Redlines completed 17-Jul - DP

Lot 17 - Duncan's Creek

The Brunswick English Country- LH

NEW HOME INC STRUCTURAL ADDENDUM LEFT HAND	REV #	REF PROJ #	DATE

ROOF FRAMING PLAN

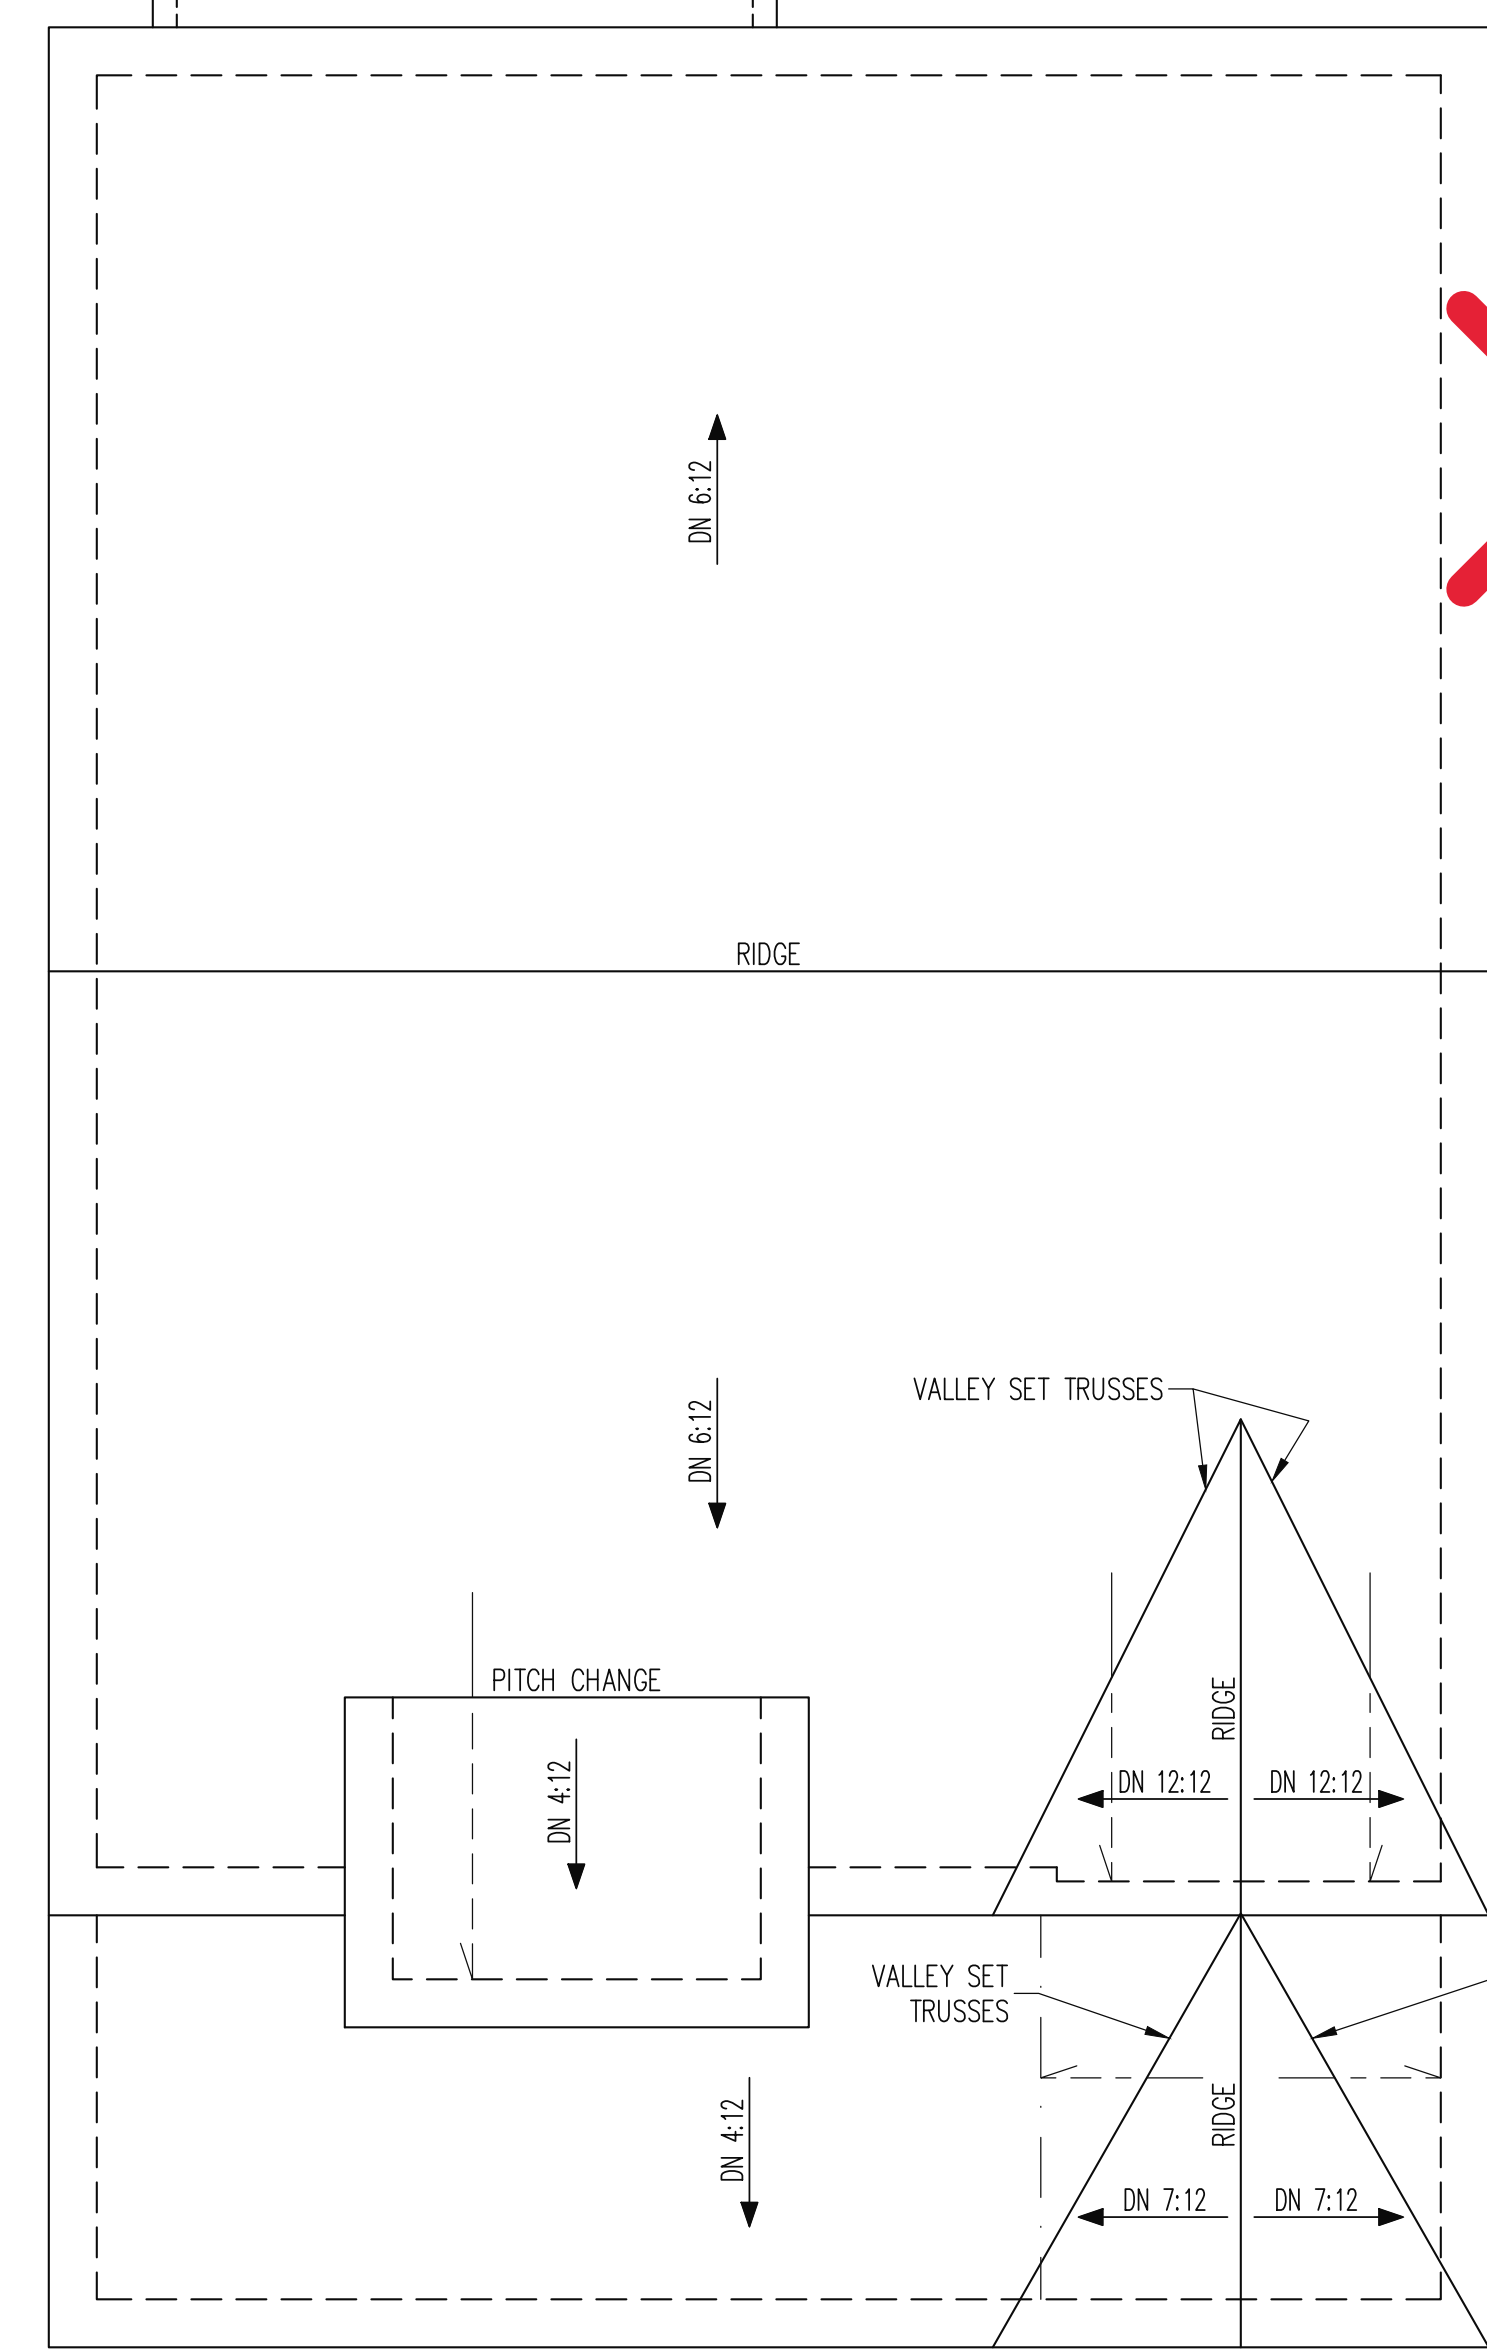
~~OPTIONAL COVERED PORCH~~

No roof over deck

~~DN 4:12, OPT. FIREPLACE~~

~~OPTIONAL MESSY KITCHEN/POWER PANTRY WITH OPTIONAL KITCHEN/CAFE~~
